**PLANNED UNIT DEVELOPMENT &  
SUBDIVISION STAFF REPORT**

**Date: June 5, 2003**

**DEVELOPMENT NAME** Springdale Mall Subdivision

**LOCATION** 3250 Airport Boulevard  
(Northeast corner of Airport Boulevard and East I-65 Service Road South, extending to the South terminus of Springdale Boulevard)

# SITE PLAN

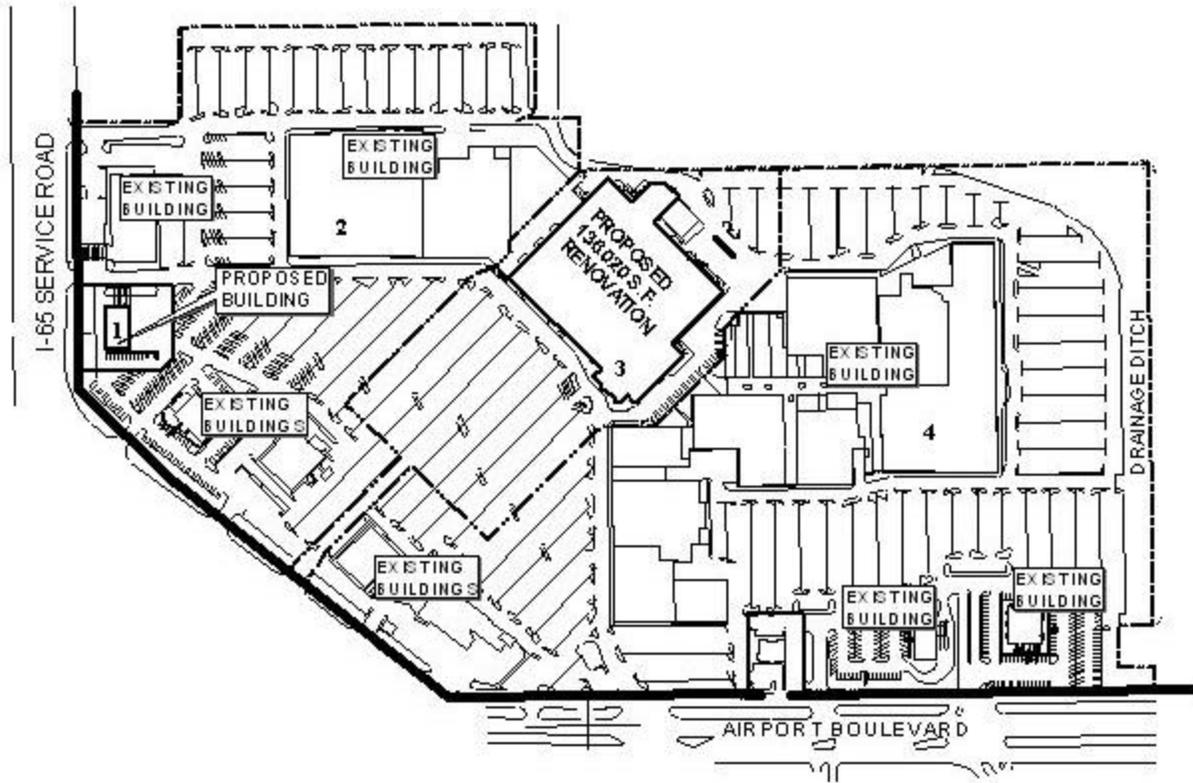
**TRAFFIC ENGINEERING COMMENTS** Driveway number, size, location, and design to be approved by Traffic Engineering and conform to AASHTO standards. Recommend review of the parking lot layout to address traffic circulation. Currently, Springdale Boulevard has an ADT of 13,600. The roadway around the building could encourage cut through traffic to Airport Boulevard and create additional traffic conflicts.
